2 Type of change

Change of rating marks on the product.

Product Change Notification					DD11 Power entry module		
owner	creation date	release date	released by	change order no	rev	page	D10-032-542
sariogar	05.12.2018	06.12.2018	limachcl	2016776	A	1 of 2

3 Detailed description of change

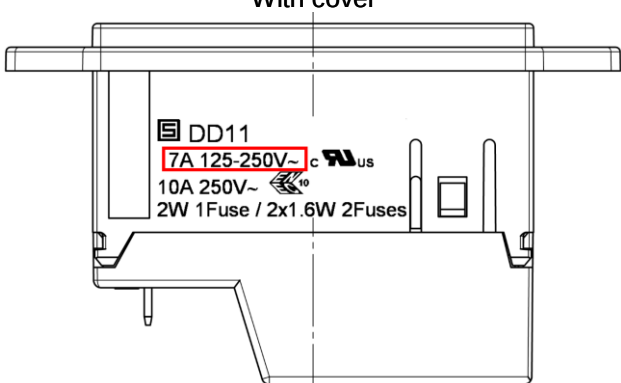
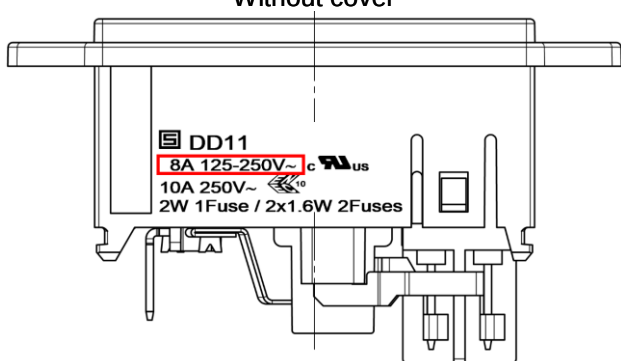
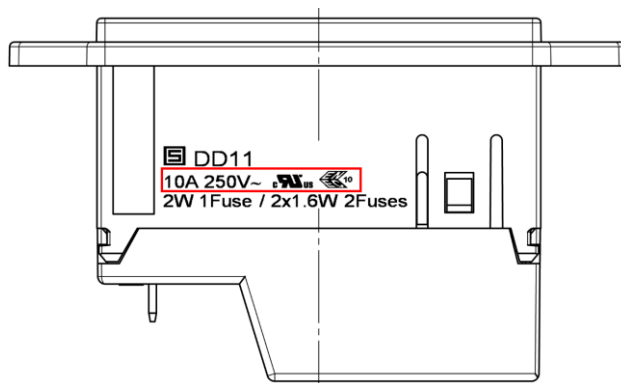
Old product rating	New product rating
With cover  Without cover 	With or without cover

Standards update according to the new UL/CSA 60320-1.
